# UNITED STATES PATENT AND TRADEMARK OFFICE

APPLICATION NO.	FILING DATE	FIRST NAMED INVENTOR	ATTORNEY DOCKET NO.	CONFIRMATION NO.
10/516,532	06/13/2005	Malcolm John Munday	15268-0001	4477

**Office Action Summary**

## DETAILED ACTION

Fig. 2A

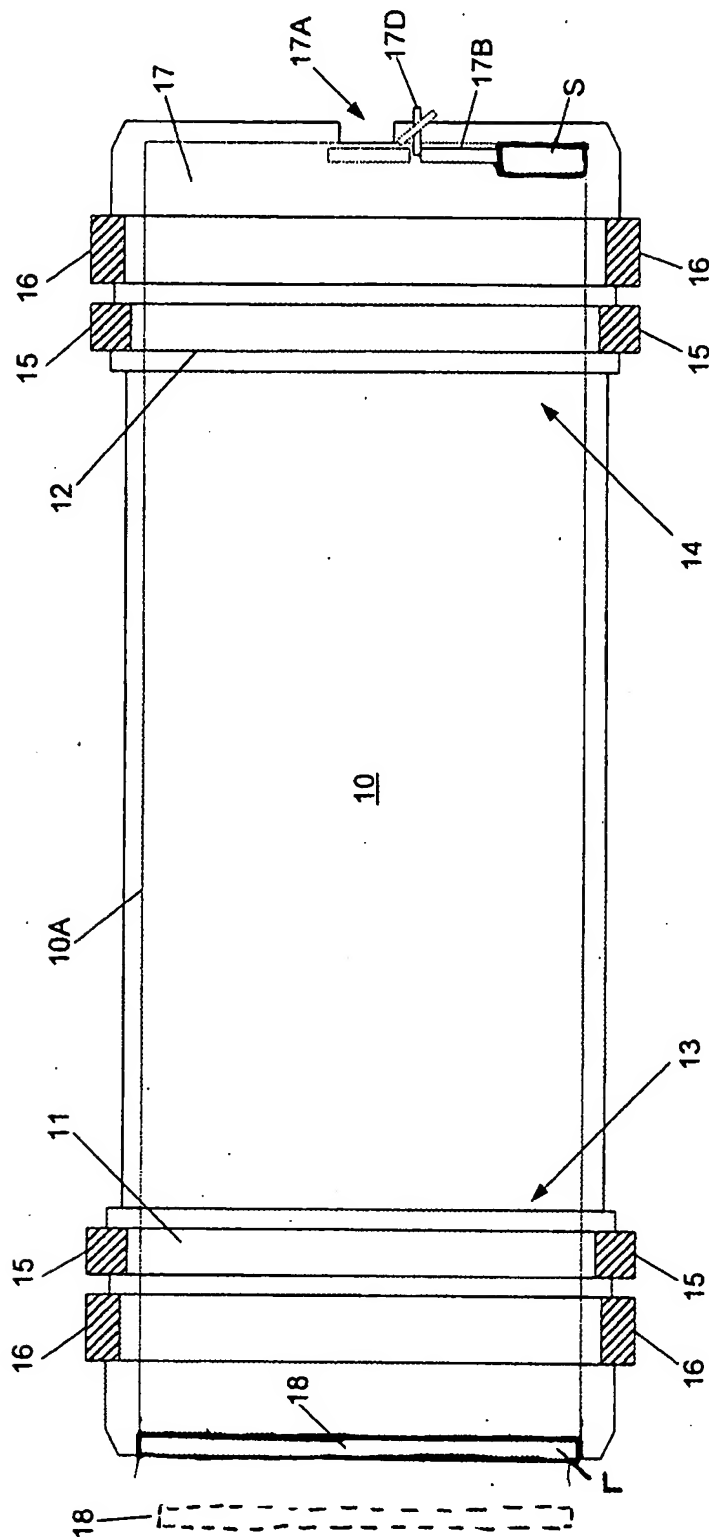
1. The proposed drawing correction of 6/6/07 has not been entered as containing new matter.

Element 18, U-shaped as seen in the Figure(s), previously indicated as an integral piece from the top reference(s) numeral 16 to the bottom reference(s) numeral 16 is now trifurcated. There are additional discrepancies.

With regard to page 11, second paragraph, the newly submitted Figure(s) shows no indication as to how the shutter is opened.

Do  
Not  
Enter  
Ex Dillon
